AMENDMENT/ADDENDUM No. 2

Solicitation Number: 2021-49RF

Description: Gas Line & HVAC Replacement at Forestbrook Middle School

9 ROOF CURB DETAIL – NEW GYMNASIUM UNIT
SCALE: NTS

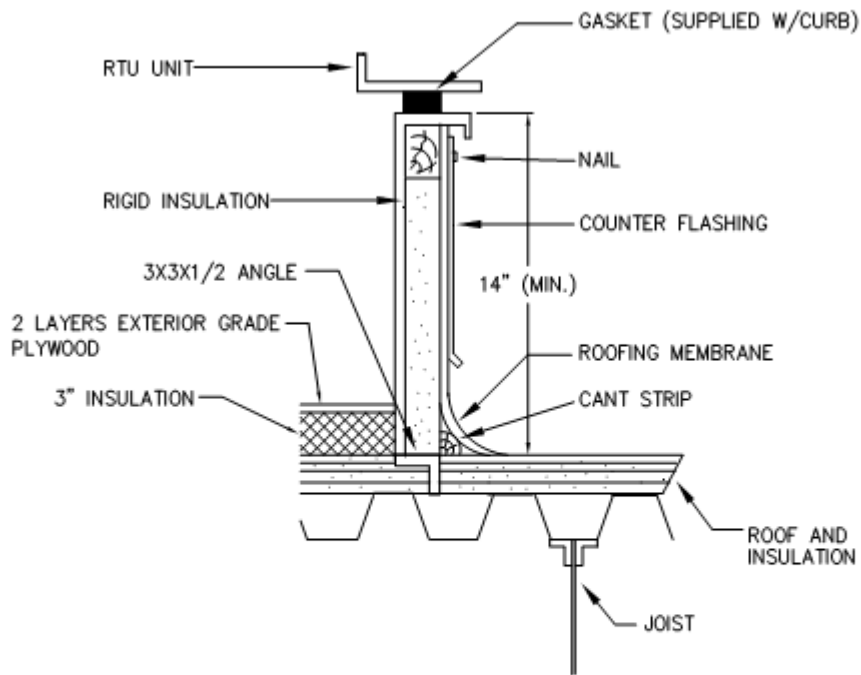
2. See below for detail for roof curb for MAU-9. New curb shall be seismic rated and shall sit on the existing deck. Roofing shall be modified as required to set and flash in new curb. Existing roof warranty must be maintained.
